Access Compliance Report Public Rights-of-Way (Curb Ramps)

Main Street: TRAILS_END_LN Cross Street: EVENINGSIDE_DR Location: SW

ADA ID: RPRK211006114401 Ramp Type: Type 1 - Perpendicular Diagonal Initial Pass/Fail: Fail Overall Compliance: No Severity Score: 15

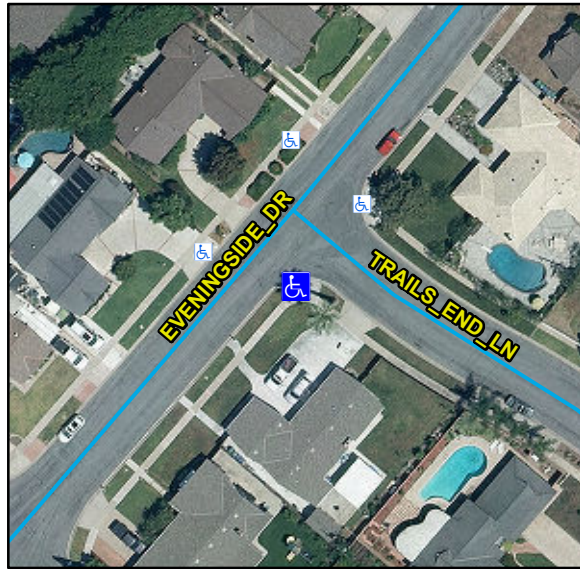
R304.2.2, R204.3, R304.5.3, STD 1115

Remove & Replace Curb Ramp With Two New Directional Ramps or Equivalent.
